From: Lee, Lani [Lani.Lee@deh.sccgov.org]
Sent: Wednesday, July 16, 2014 7:32 AM
To: Rebecca Tolentino
Subject: Parkside Trails Project MND

This response to the proposed Parkside Trails Development addresses the mitigation of the proposed project entrance off of Stevens Canyon Road presented in the Parkside Trails Initial Study, section 4.16.2.2. Specifically, the study points out that the Fehr & Peers traffic study found that the proposed intersection of Stevens Canyon Road and "A" Street of the project does not meet the Caltrans CSD sight distance standards for southbound vehicles, and could result in an increase in hazards due to a design feature (Significant Impact). The proposed mitigation preference is Option 1.2A because it provides an additional 10 feet of southbound travel to mitigate the deficiency.

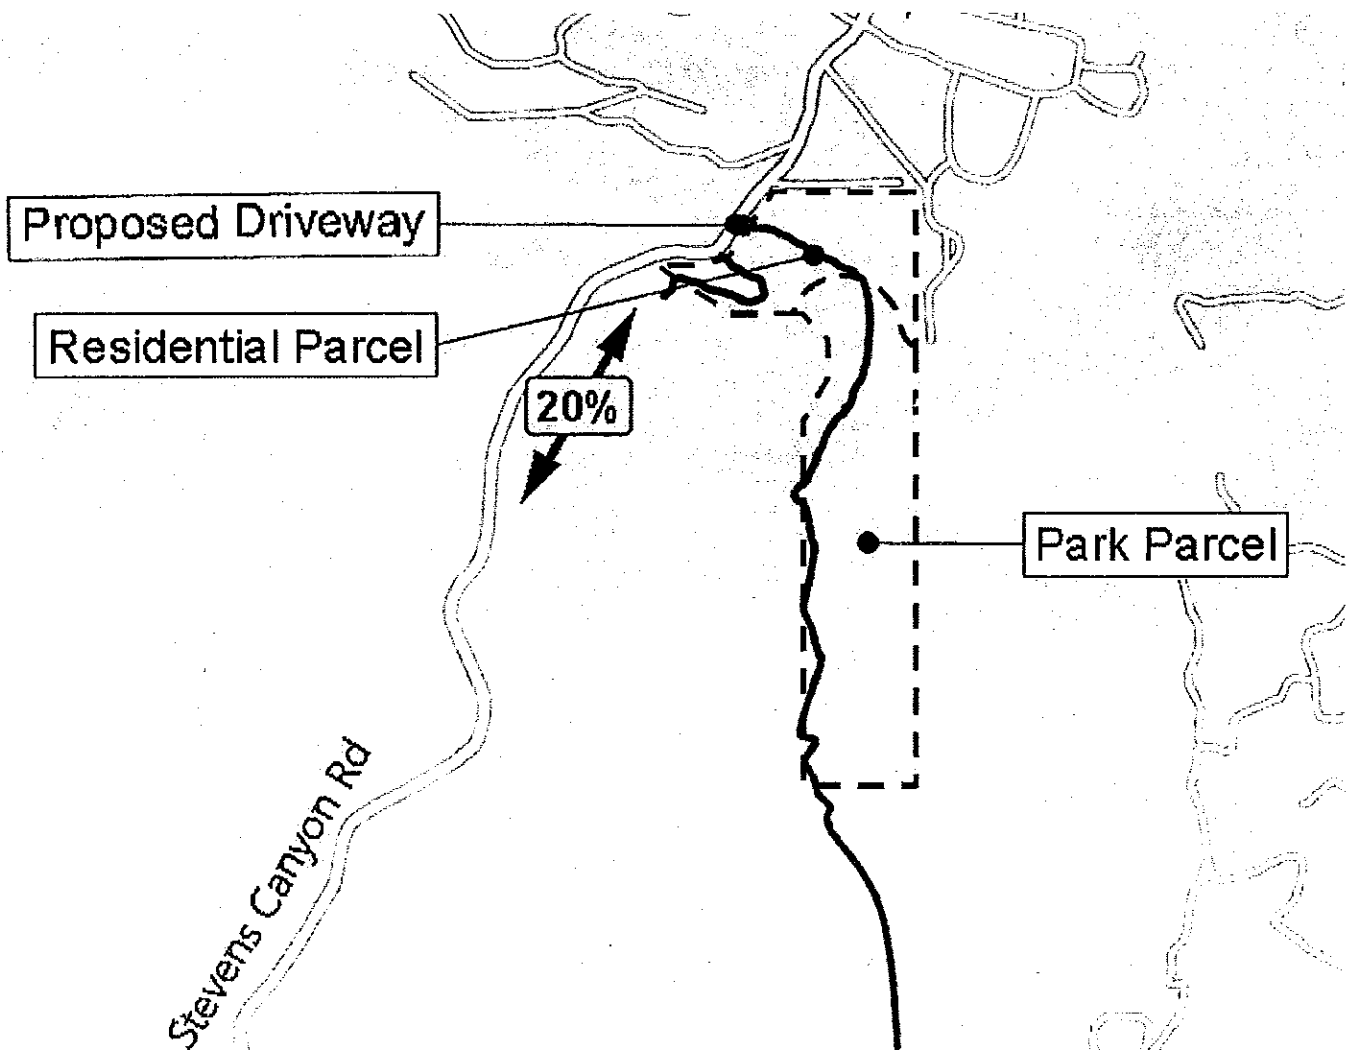
The report really should address mountain bike access into the Steven's Creek park from the roadway. Today, only pedestrian access is discussed below:

The problem is that the road between this property and the official Steven's Creek Park entrance is very narrow and prone to speeding and biking accidents with cars. The numerous memorials along this section of road attest to the high level of lethal danger on this section of road. I am not sure if this is due to Kaiser cement trucks, or locals in a hurry around what is a blind corner in the picture above. A big mirror on that turn may also help...

I see two acceptable solutions to this drawn on the map below where the current situation with how this land is used today would not be negatively impacted:

1. Reroute the existing access to maintain the current path into Steven's Creek Park lower parking lot for bike access in **RED**. This existing path today does not violate the Steven's Creek park bike policy because it is not part of Steven's Creek park.
2. Allow Bikes through what is now private property in the old quarry that is marked Park Parcel in **GREEN**. The road in green is a ridgeline trail that is largely already existing. It would not take a lot to get this path to become a bike friendly entrance alternative to Fremont Older's highlands and would not conflict with the no bikes policy of Steven's Canyon Park. In many ways this would be a very welcome extension to the Fremont Older Park. Park Trails would need to give up a public easement to allow access however.

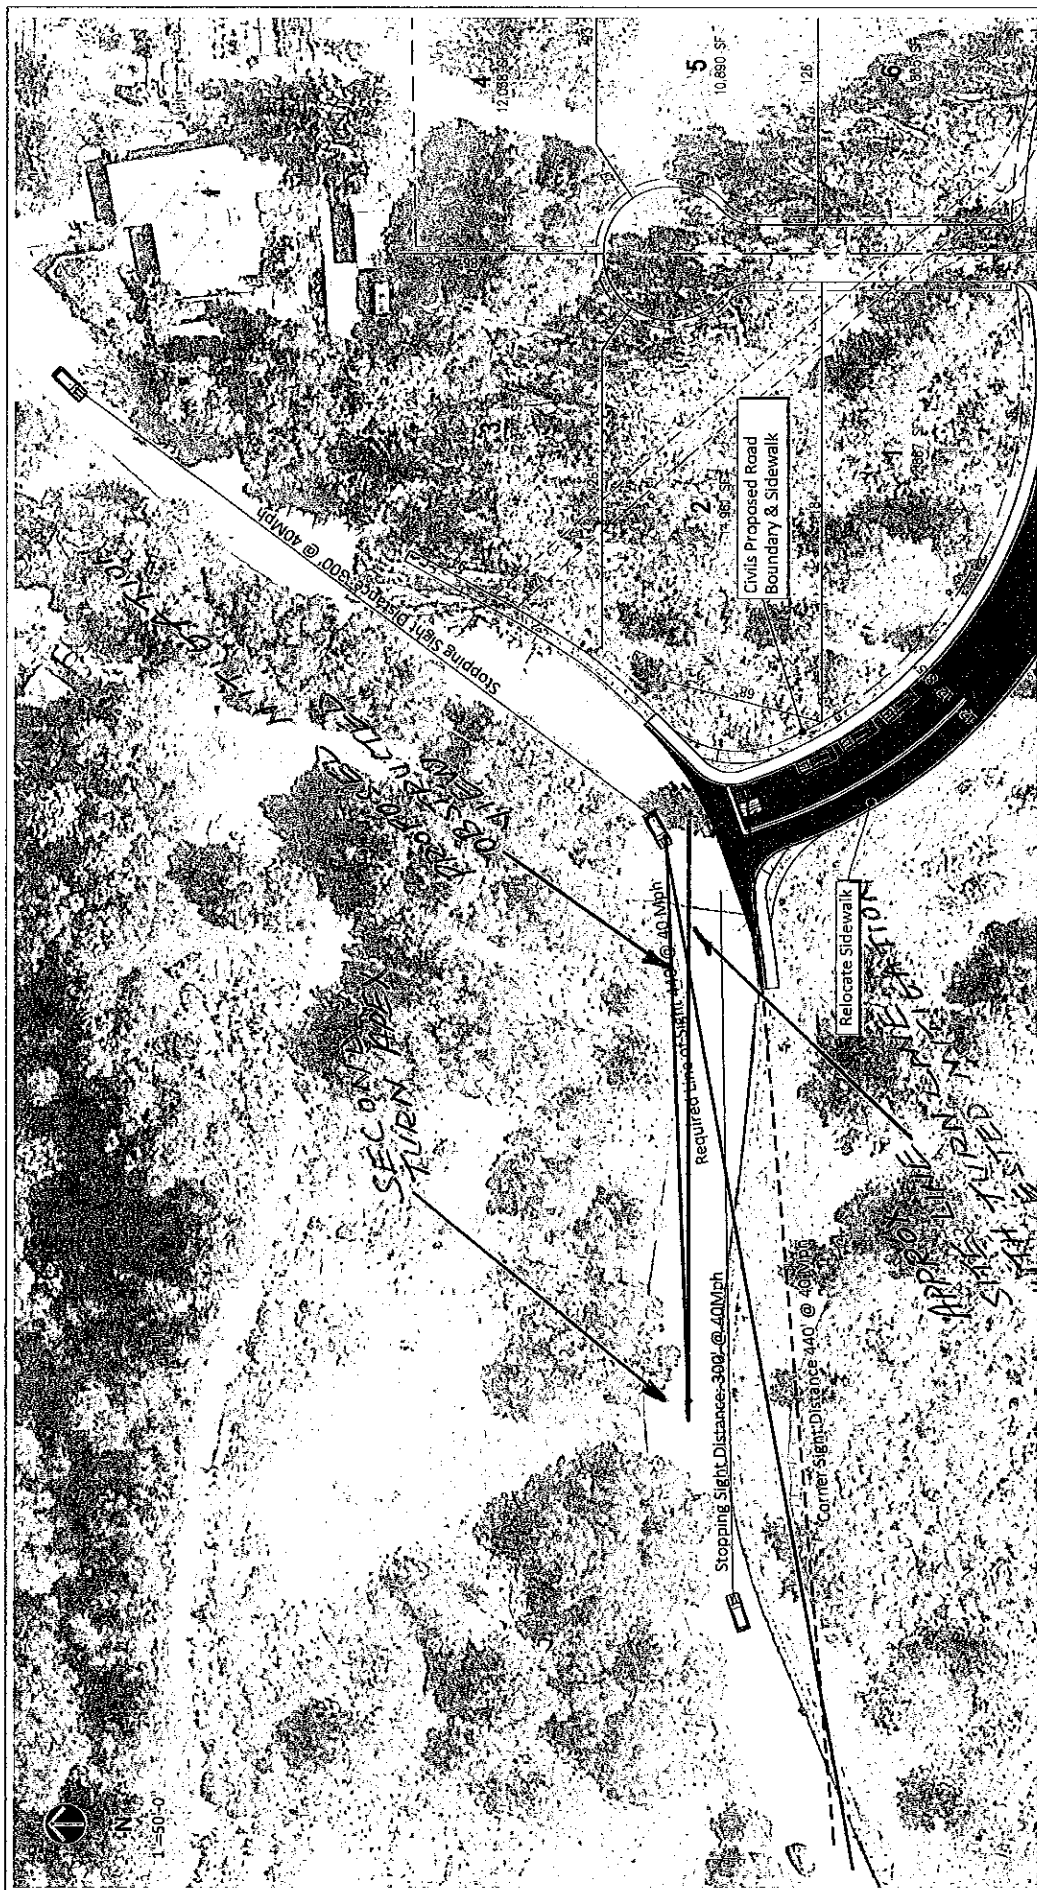
5. The proposed entrance to the project is at the apex of the first turn of a reverse "S" turn. Figure 1 attached is a copy of the proposed mitigated corner provided by Fehr and Peers which demonstrates that the mitigation insufficiently mitigates the CSD as the site line to the apex of the second corner is obstructed. Smaller vehicles including motorcycles, bicyclists, and small cars may disappear from view as they proceed northbound through the apex of the second corner to the west of the proposed entrance and thus be hidden from view of a turning driver.

It should be noted here that any review of the conditions at the proposed development entrance should be viewed in person. It is difficult to appreciate the potential dangers associated with the location without a site visit. At the site, one can fully appreciate the circumstances and imagine how frightening executing a turn into the site might be for a partially distracted driver dealing with oncoming and trailing traffic, particularly intimidating trucks. By observing, particularly the southbound truck traffic at the site entrance, it can easily be imagined the potentiality of them coming to a stop at the corner to permit a turning vehicle, and then slowly accelerating westward behind a completely blind turn.

The site location is dangerous, and the proposed mitigation is insufficient. Given that the F & P traffic study has determined that the project will generate over 750 attempted entrances to the site weekly, and over 39,000 annually, planners and decision makers need to re-evaluate this potential hazard and consider an alternative mitigation as suggested above.

Proposed Alternative: A complete mitigation of the dangerous entrance could be achieved by requiring a southbound turning lane into the project off of Stevens Canyon Road. The benefits would be:

15) 4.9.3.3 Drainage and Runoff Impacts, Offsite Stormwater Runoff, page 145. Text reads,

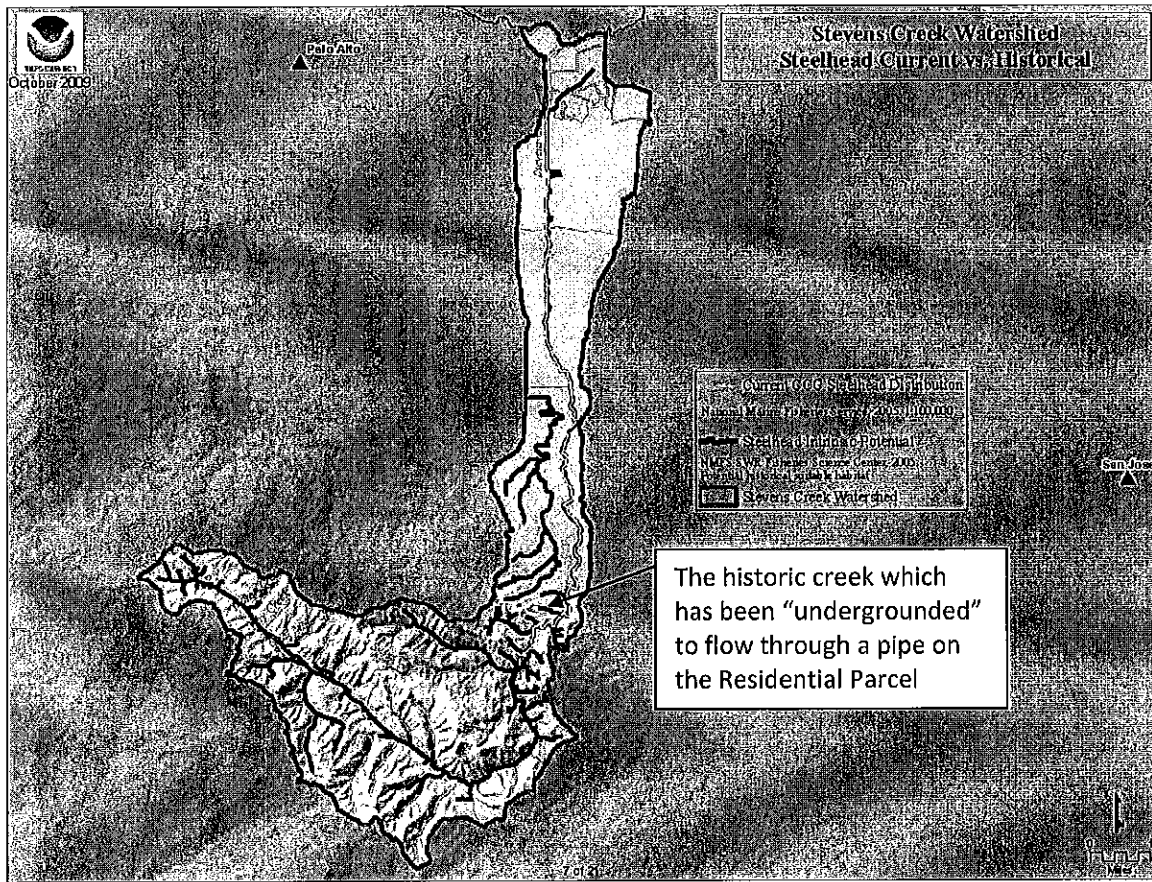
“An existing outfall to Stevens Creek is located on the Corridor parcel. Under existing conditions, offsite stormwater runoff from Stevens Canyon Road and approximately 28 acres west of the project site across Stevens Canyon Road is conveyed through the Residential parcel in an 18-inch storm drain line to the existing outfall. The offsite stormwater runoff would continue to be routed through the Residential parcel to the existing outfall under the proposed project, with the following modifications:

- The 18-inch storm drain line would be rerouted through the Residential parcel within the proposed street.
- The storm drain system on Stevens Canyon Road would be improved to prevent localized flooding.”
